DART SERVICE INSTRUCTION

TO AMEND INSTALLATION INSTRUCTIONS IIN-D407-781-2 REV. A OR LATER APPROVED REVISION
AND INSTRUCTIONS FOR CONTINUED AIRWORTHINESS ICA-D407-781 REV. 3 OR LATER REVISION

REF. TCCA STC: SH08-60
REF. FAA STC: SR002726NY
REF. EASA. IM.R.S.01541

**FIGURE 1 - D3879-1 BAGGAGE COMPARTMENT WALL
PROTECTOR - ALTERNATE INSTALLATION**

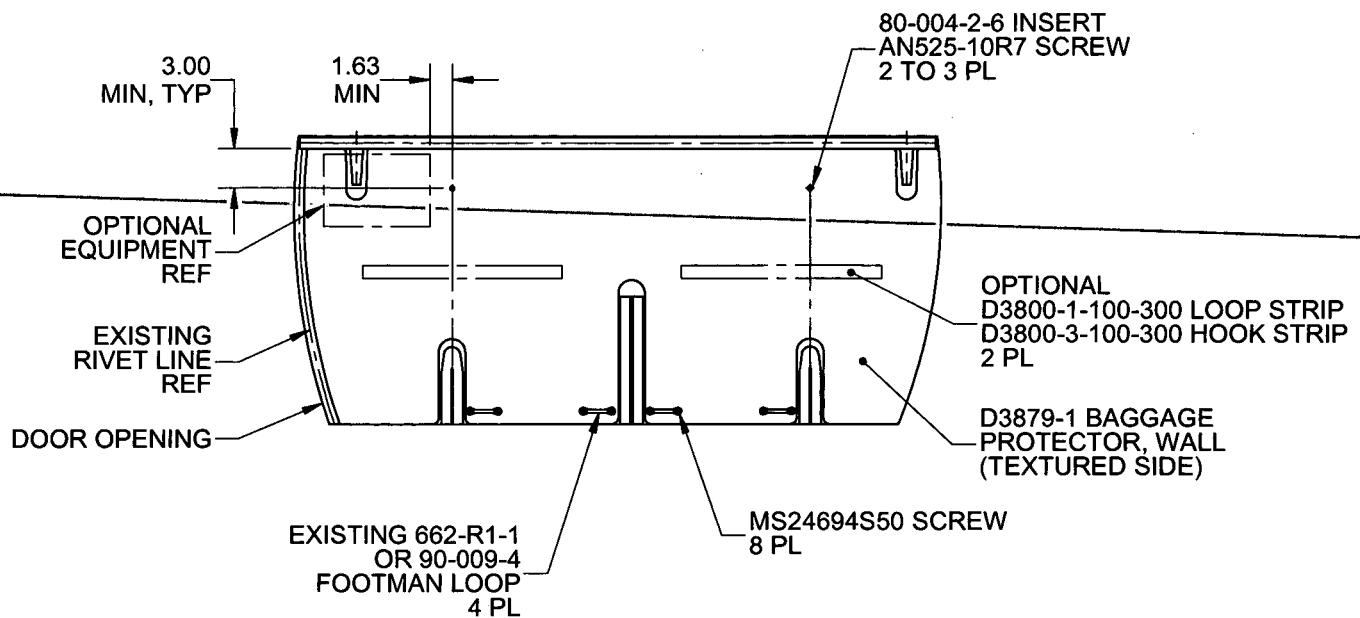
In some aircraft, the top portion of the D206-781-041 Baggage Compartment Wall Protector Kit cannot be installed as indicated in IIN-D407-781-2. The purpose of this DSI is to provide an alternate mounting method to fasten the top portion of the D206-781-041 Baggage Compartment Wall Protector Kit.

It is acceptable to replace qty(2) D3930-1 Clips with qty(2) 80-004-2-6 Inserts. Locate and mark location of the two attachment holes on the baggage compartment wall as shown in Figure 1 of this service instruction. Install 80-004-2-6 Inserts at the marked locations in accordance with Section 3-2-12 of BHT-206-SRM-1. It is acceptable to trim the wall protectors to accommodate optional equipment or transfer attachment holes to the wall protector and install the optional equipment on top of the wall protector with longer fasteners.
